In-vehicle battery durability e-HDVs

Open Items

Elena Paffumi, Gian-Luca Patrone
EVE IWG 74th, Tokyo, Japan

September 18th-19th, 2024

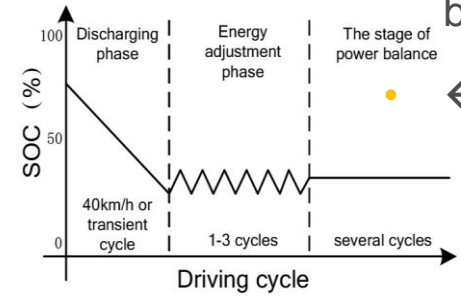
← China proposal

Japan: at least 1500sec ?
 JE05 : 1830 sec
 WLTP 4 : 1800 sec
 WLTP 3 : 1477 sec

Japan: 4 per cent of cumulative UBE

- [the vehicle cannot drive in pure electric mode for [4] consecutive seconds or more without recuperation from the engine operation]
- [the $|\Delta E_{REESS,dt}|$ in the last xx dt of driving is equal to or less than xx per cent of the ~~total nominal energy capacity of the battery~~ **cumulative UBE**. The manufacturer shall provide evidence to the responsible authority after the test that this requirement is fulfilled.]
- [For HD-OVC-HEV, the end of the charge-depleting test is considered to have been reached at the end of the energy adjustment phase when the break-off criteria is reached for the first time in the stage of power balance.]

e-HDV's tests open questions: Break-off criterion EVE IWG 71st

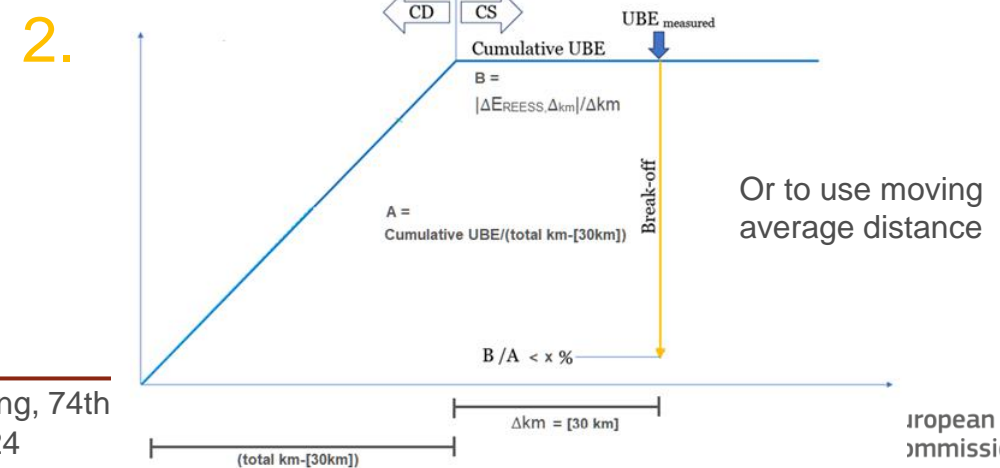
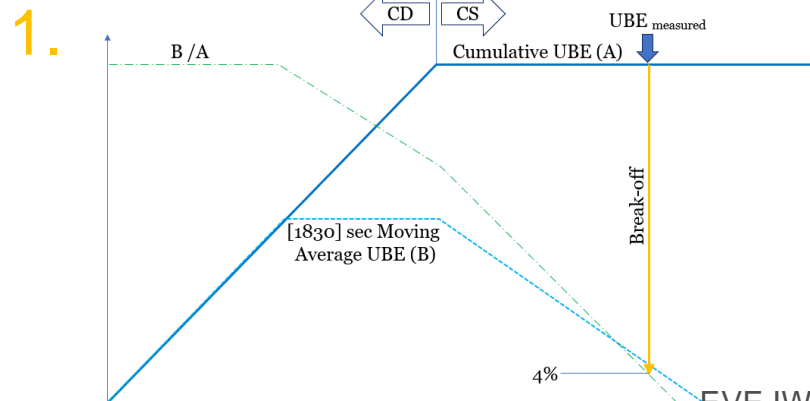
Japan: at least 1500sec ?
JE05 : 1830 sec
WLTP 4 : 1800 sec
WLTP 3 : 1477 sec

Japan: 4 per cent of cumulative UBE

30 km ?

2-3-5 per cent ?

1. [the $|\Delta E_{REESS,dt}|$ in the last xx dt of driving is equal to or less than xx per cent of the cumulative UBE. The manufacturer shall provide evidence to the responsible authority after the test that this requirement is fulfilled.]

2. [the $|\Delta E_{REESS,\Delta km}|/\Delta km$ in the last xx km of driving is equal to or less than xx per cent of the cumulative UBE/(total distance travelled - Δkm) (energy consumption before the last Δkm). The manufacturer shall provide evidence to the responsible authority after the test that this requirement is fulfilled.]

Method 1a Discharge by standard average speed on a test track

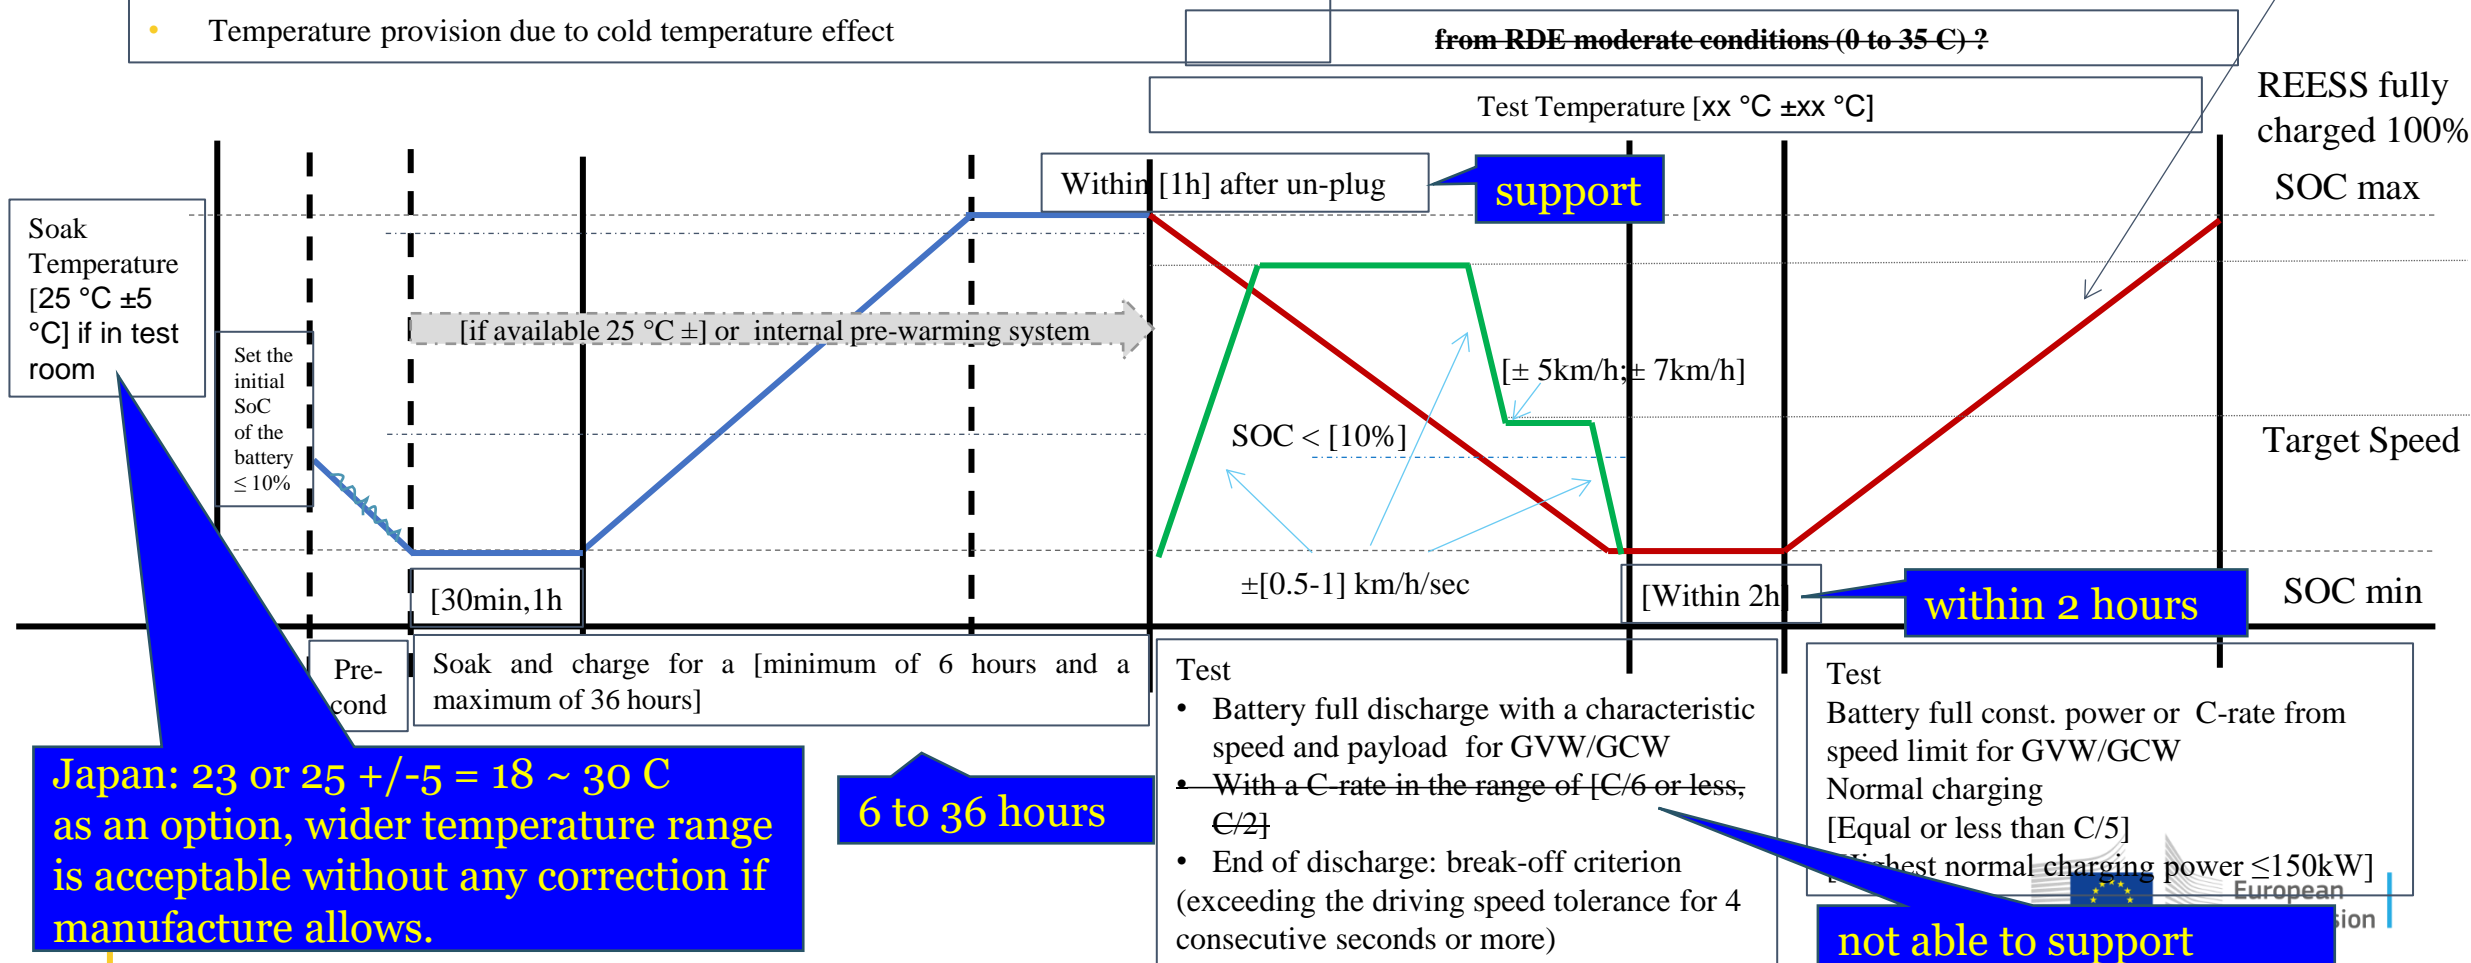
- Range of speed per category per region track
- To leave open the speed for the test and prescribe only the target speed in the last part of the test for which a speed tolerance will be applied
- The last part of the test starts when the SOC < [10%] (to be verified)
- Speed tolerance in last test segment [$\pm 5\text{km/h}; \pm 7\text{km/h}$]
- The acceleration/deceleration during vehicle speed change shall be smooth and accomplished within the range $\pm[0.5-1]$ km/h/sec
- End of discharge: break-off criterion
- Temperature provision due to cold temperature effect

from RDE moderate conditions (0 to 35 C)?

Japan: 23 or 25 +/-5 = 18 ~ 30 C as an option, wider temperature range is acceptable without any correction if manufacture allows.

- Agreed as reported in the following slides ✓
- Soak and charge temperature [25 °C ±5 °C] if in a test room ✓ agreed
- Soak and charge for a minimum of 6 hours and a maximum of 36 hours ✓ agreed
- ~~With a C-rate in the range of [C/6 or less, C/2]~~ to remove this requirement since there is already the requirement on the speed ✓ agreed . **To leave it in Method 2**
- If on-board system are used to complete the REESS depleting due to safety reason (method 1a and 1b) , c-rate? (Typically is automatically set). Criterion for stopping the test?
- Variability of test methods, the same test method in certification and ISC,..if UBE is declared which is the test to keep in ISC “the same”?
- “A” parameter revision, based on data

Method 1b Discharge by driving on the road with average speed

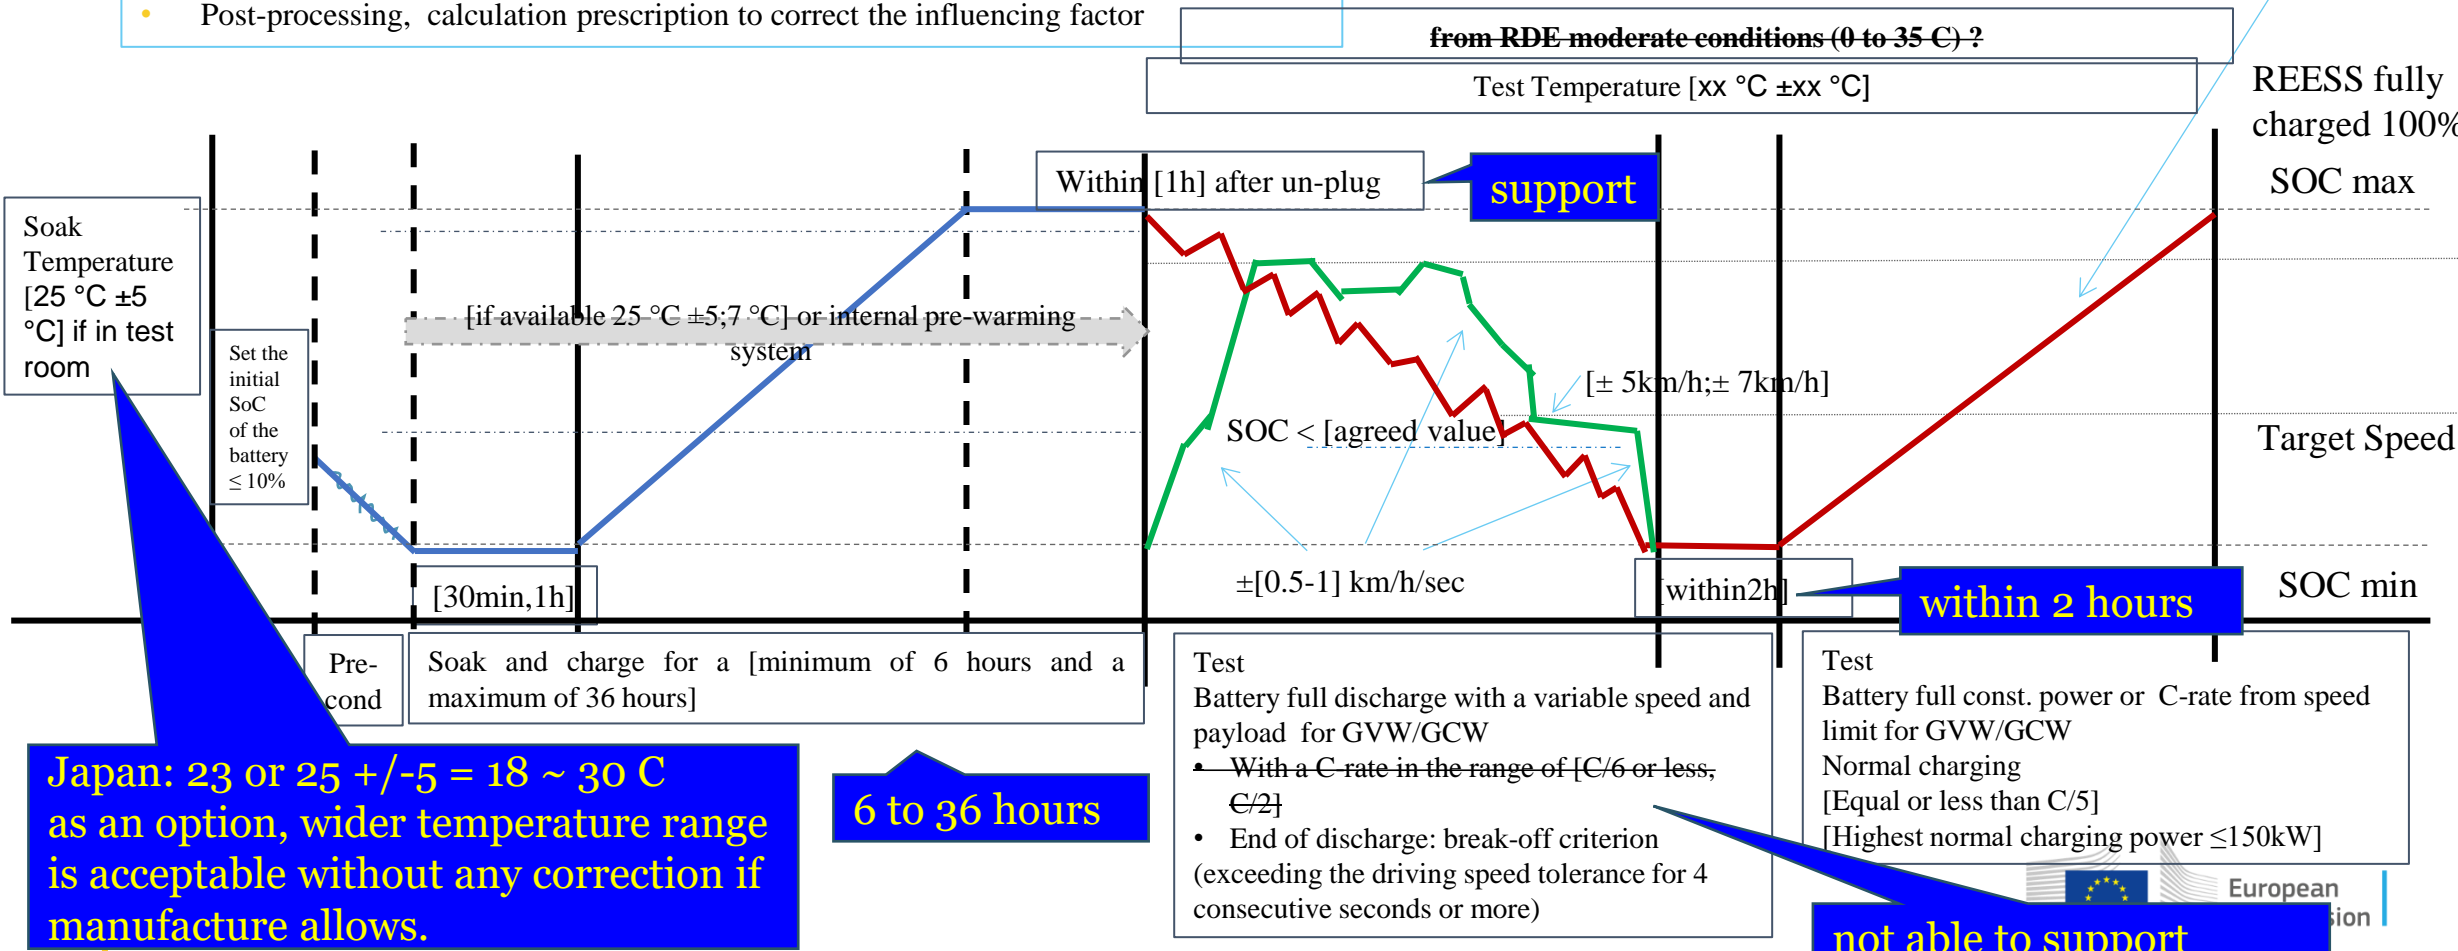
- Range of on-road speed per category per region
- To leave open the speed for the test
- The last part of the test starts with a given SOC level
- Some agreement with local regional authority for SOC minimum level and test
- Same route as type approval or different in accordance with regional authority
- If same routes is used, different provision on minimum SOC level and test
- Speed tolerance? in last test segment ?
- The acceleration/deceleration during speed change shall be as smooth as possible in relation to traffic conditions and safety of driving
- Post-processing, calculation prescription to correct the influencing factor

Japan: 23 or 25 +/- 5 = 18 ~ 30 C as an option, wider temperature range is acceptable without any correction if manufacture allows.

Method 2 bidirectional charging system available

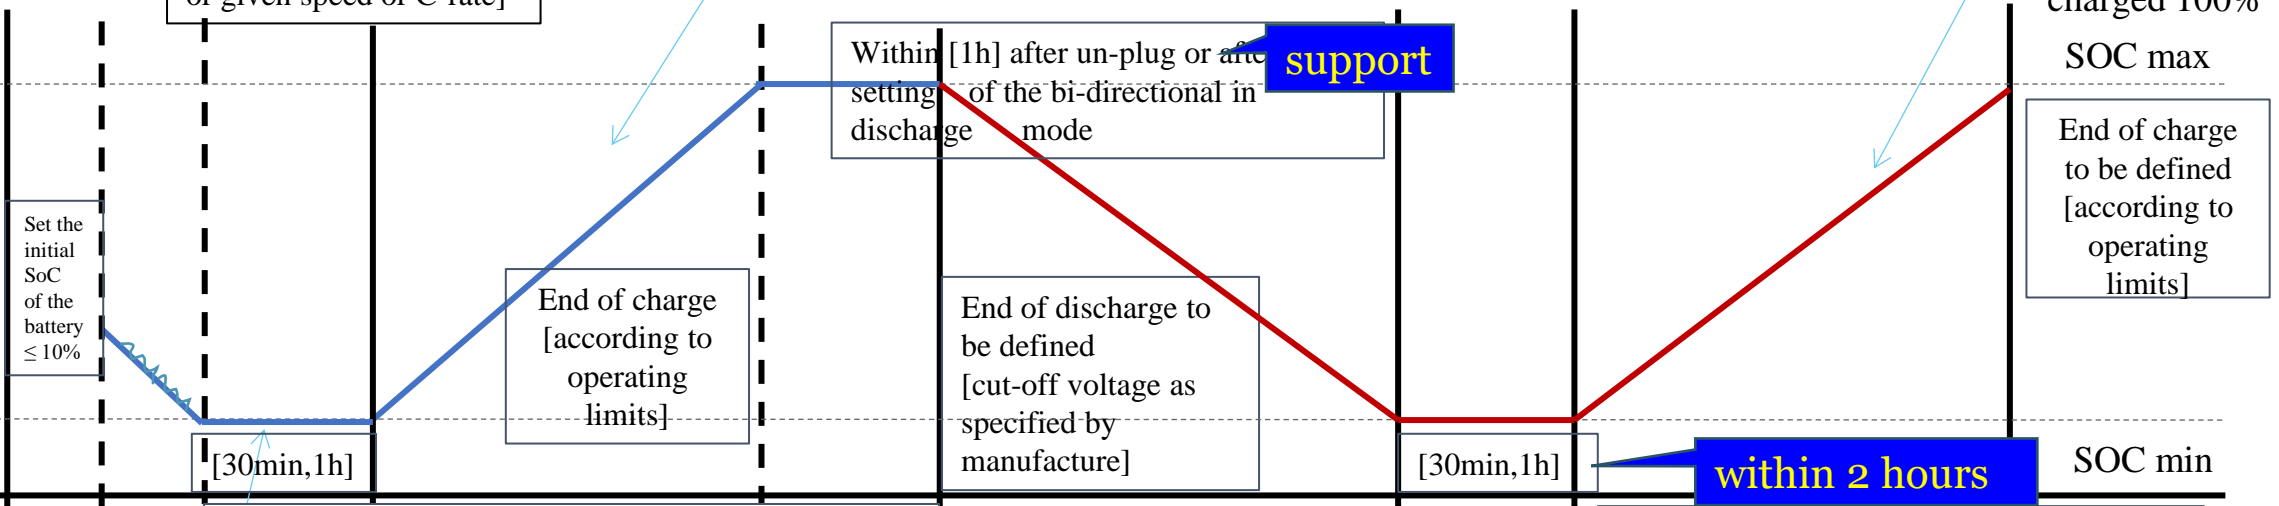
Japan: 23 or 25 +/- 5 = 18 ~ 30 C as an option, wider temperature range is acceptable without any correction if manufacture allows.

End of discharge to be defined for bi-directional charging test [Cut-off voltage]
